Application for change or cancellation of resource consent condition (S.127)

Change of conditions (s.127)

Northern Land Investment Limited

TITLE
 CURRENT TITLE SITUATION
 PROPOSED SUBDIVISION
 OF LOT 1 DP 43502 &
 LOT 3 DP 115118

DATE	MAY 2026	SCALE	1:2500 @A3
NO.	S17700	SHEET	1/4
		REV.	E

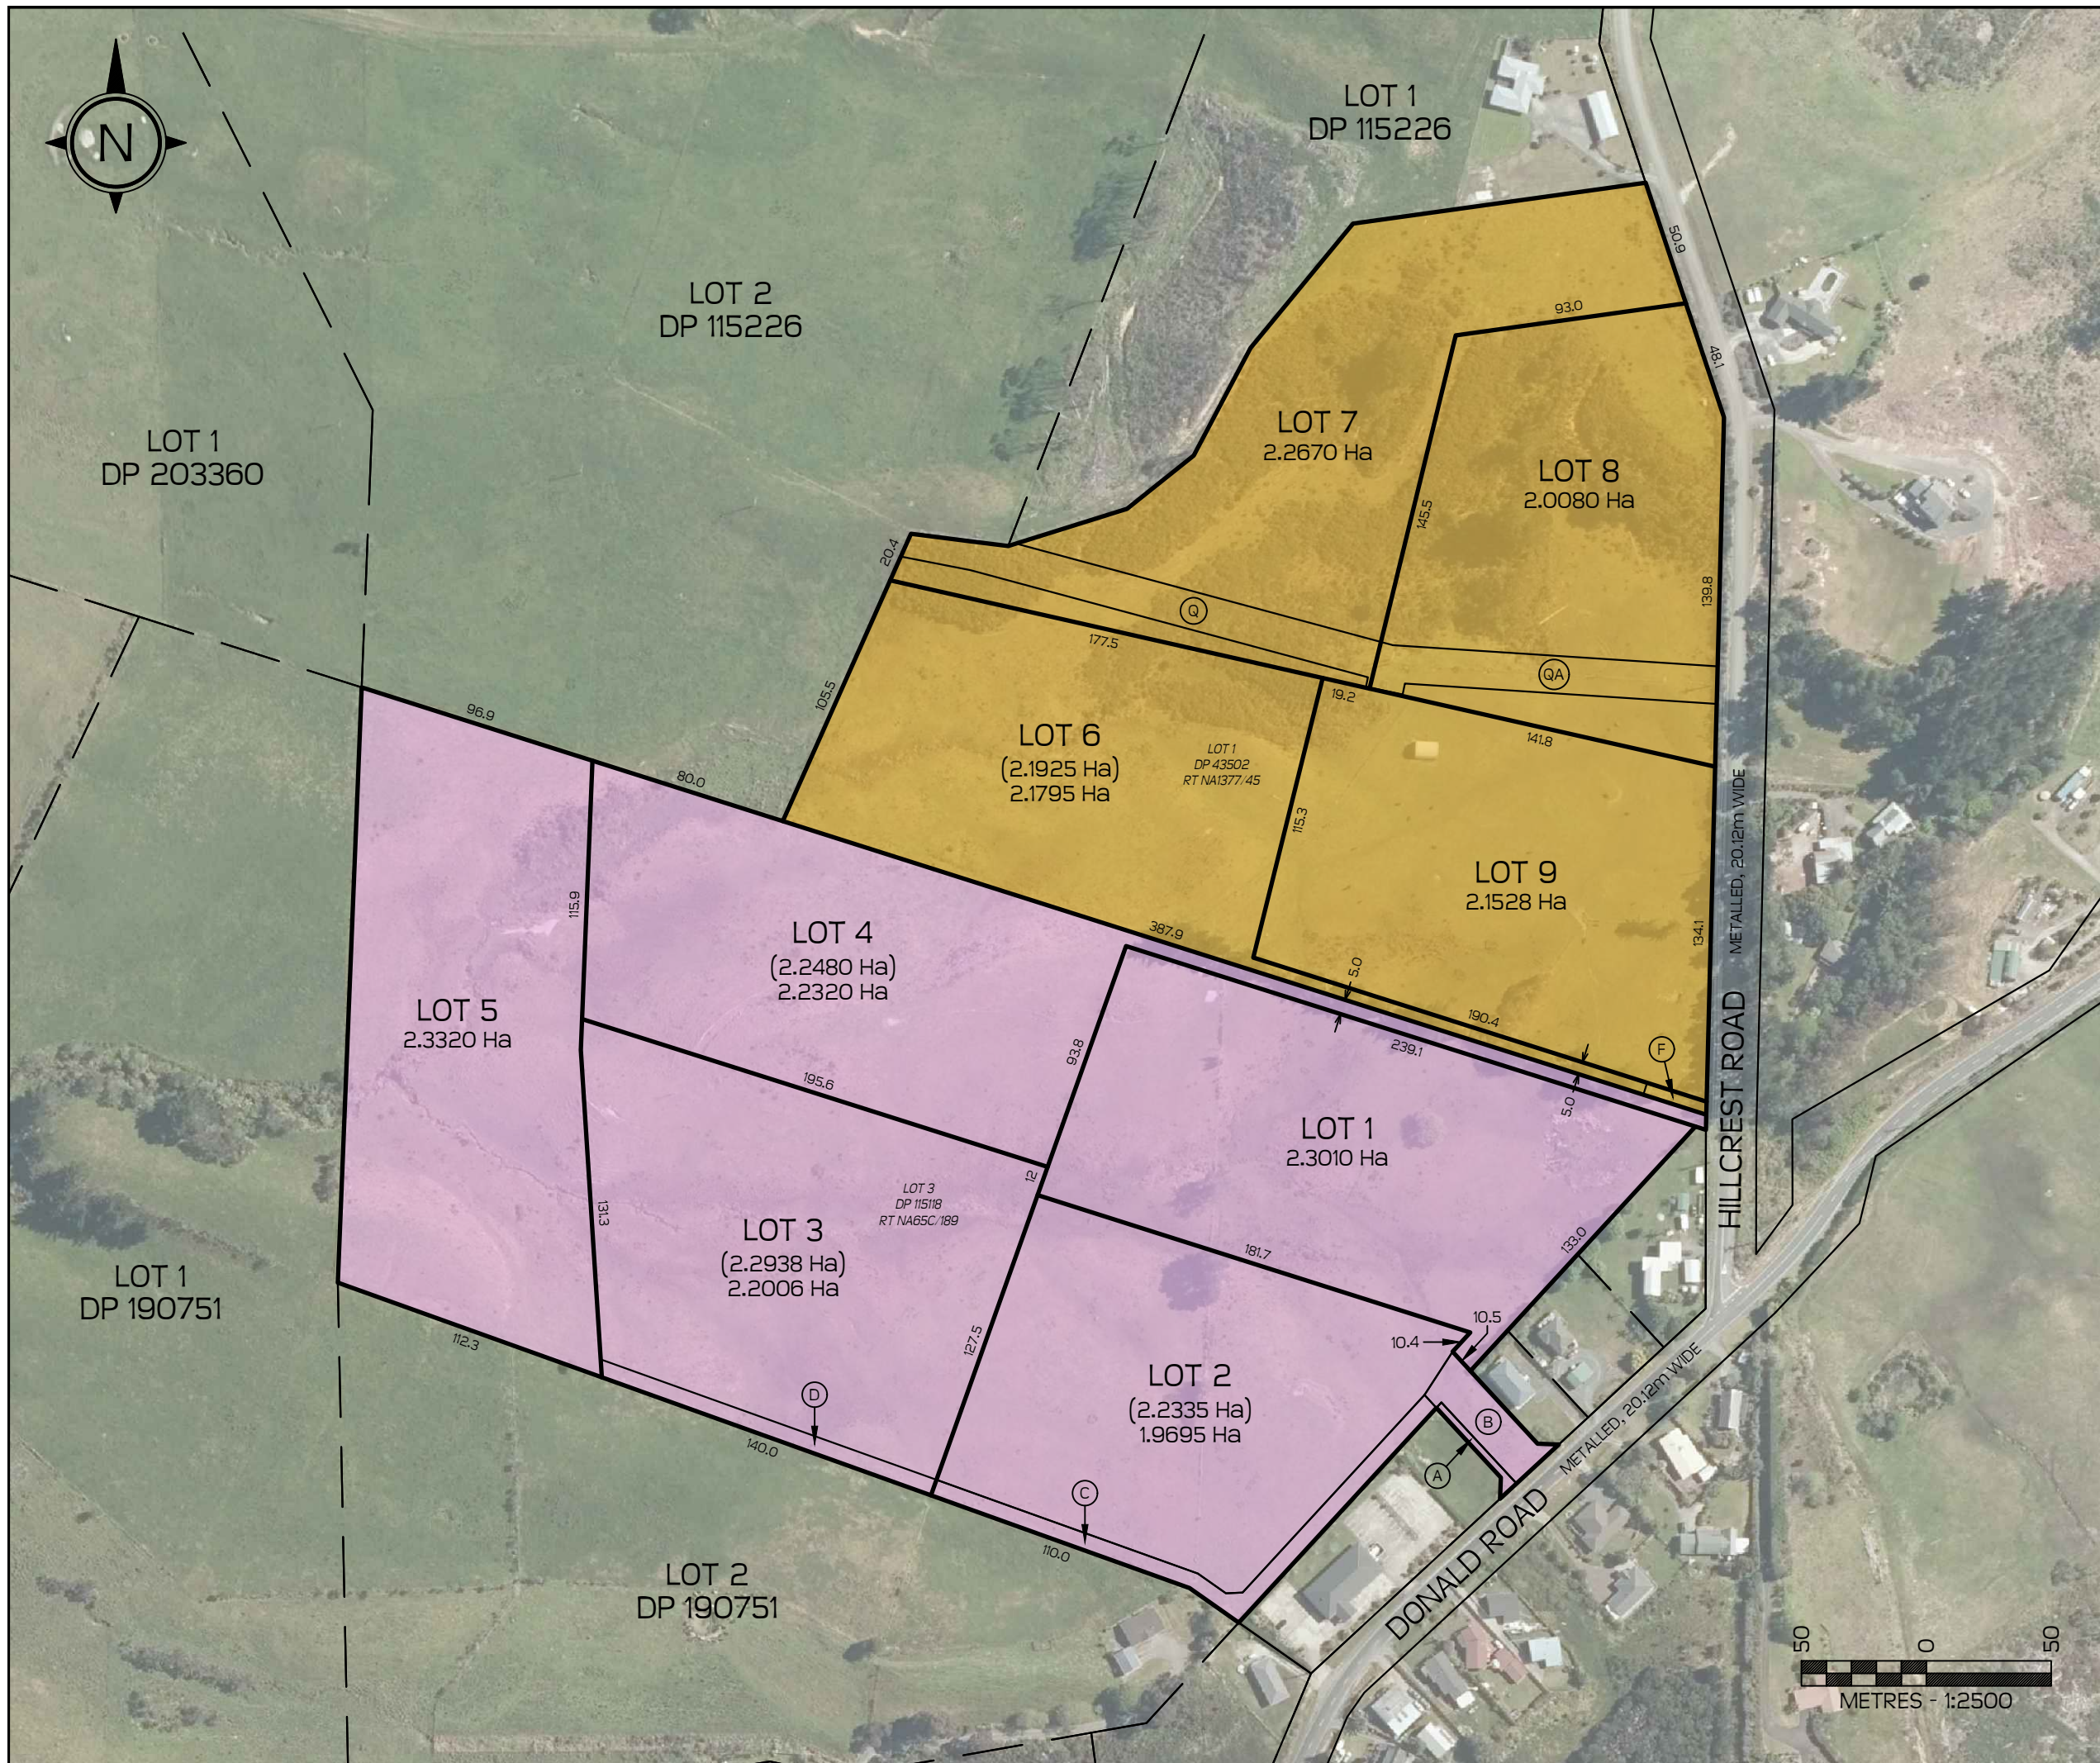
6. **Stage 1:**
 - Creation of Lots 6, 7, 8, and 9.
 - Establishment of Right of Way 'F' to provide legal access to Lots 6 and 9.
 7. **Stage 2:**
 - Creation of Lots 1, 2, 3, 4, and 5.

- Establishment of Rights of Way 'B', 'C' and 'D' to provide legal access to Lots 1, 2, 3 and 5.
8. An amended scheme plan (Rev D) is **enclosed**.
9. In addition to the staging above, changes are also proposed to the access arrangements associated with Lots 1, 4, 6 and 9, where:

- Lot 1 will instead be accessed from right of way 'B'.
 - Lot 4 will be accessed via an individual pan-handle driveway.
 - Lots 6 and 9 will share an accessway shown on the scheme plan as right of way 'F'.

REV	DATE	DESCRIPTION
E	01.05.26	REMOVING ROW E - SN/KM
D	03.03.26	STAGING - JBH/KM
A	09.08.23	FIRST ISSUE - JBH/TM

DATE	AUGUST 2024	SCALE	1:2500 @A3
NO.	S17700	SHEET	1/1 Rev. C

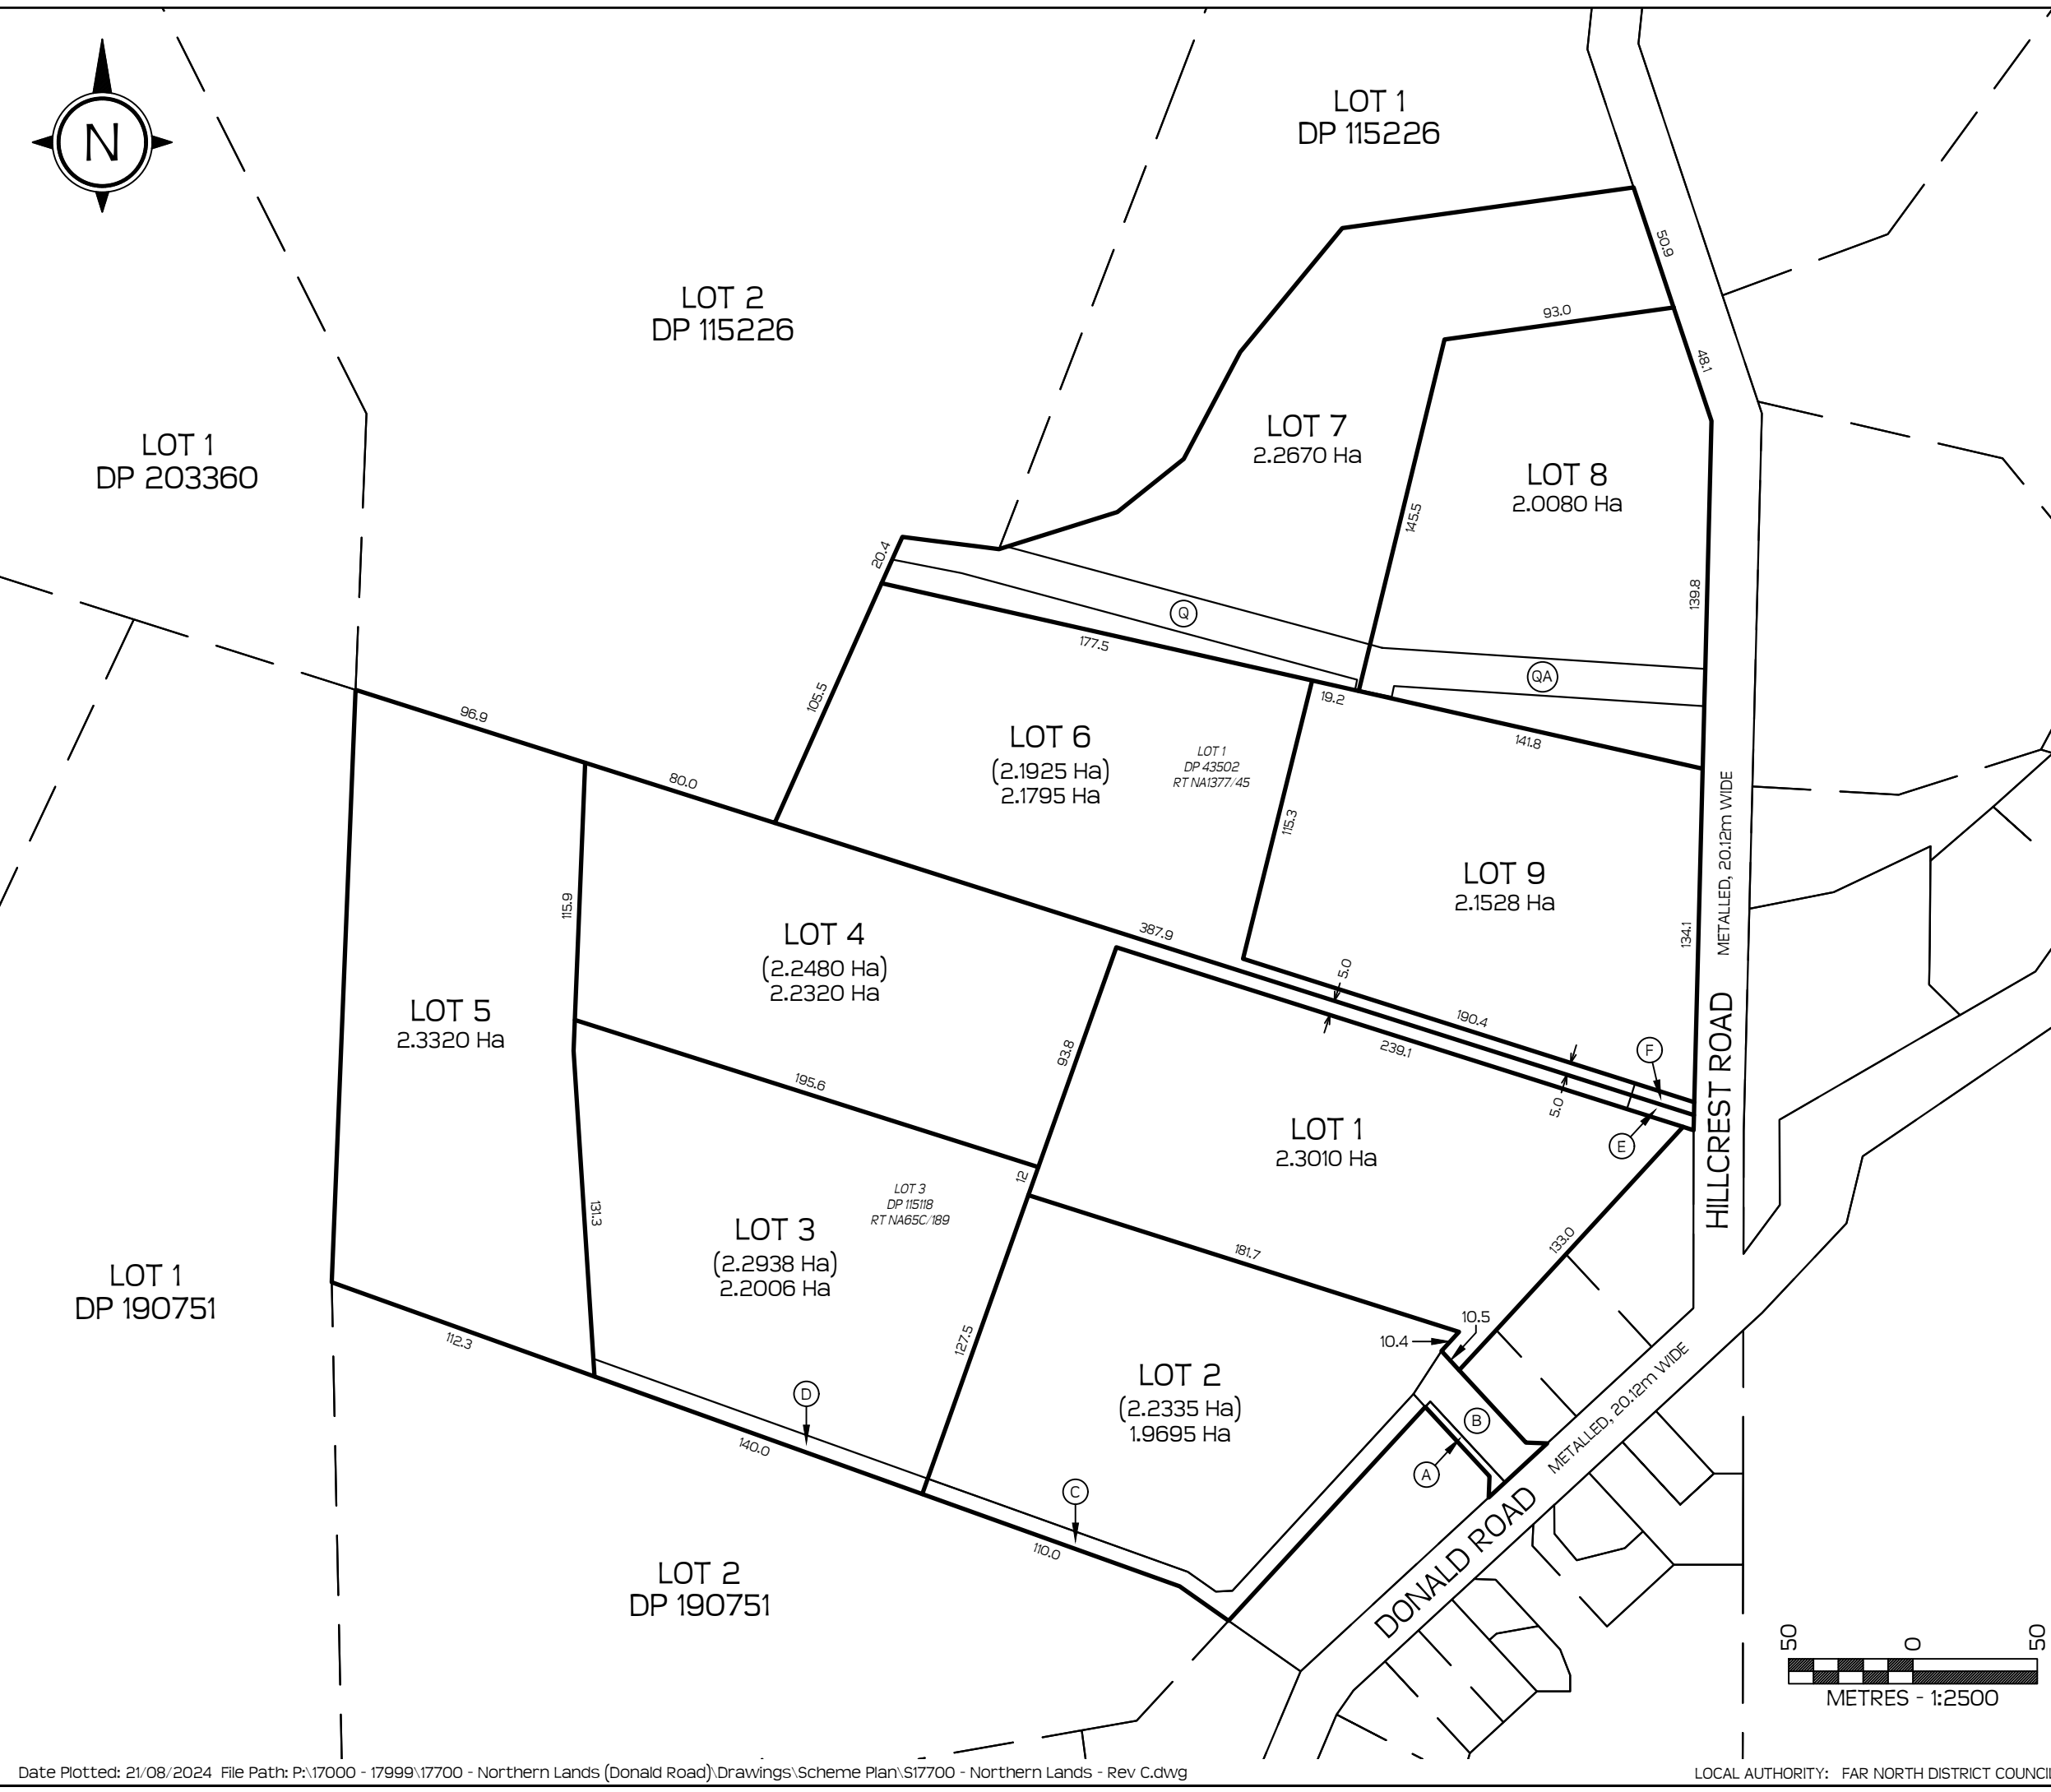
1. The subdivision shall be carried out in accordance with the approved plan of subdivision prepared by Reyburn & Bryant, titled 'Proposed Subdivision of Lot 1 DP 43502 & Lot 3 DP 115118', referenced S17700, REV C, dated August 2024 and attached to this consent with the Council's "Approved Stamp" affixed to them.

1. The subdivision shall be carried out in accordance with the approved plan of subdivision prepared by Reyburn & Bryant, titled 'Proposed Subdivision of Lot 1 DP 43502 & Lot 3 DP 115118', referenced S17700, REV D, dated August 2024 and attached to this consent with the Council's "Approved Stamp" affixed to them.
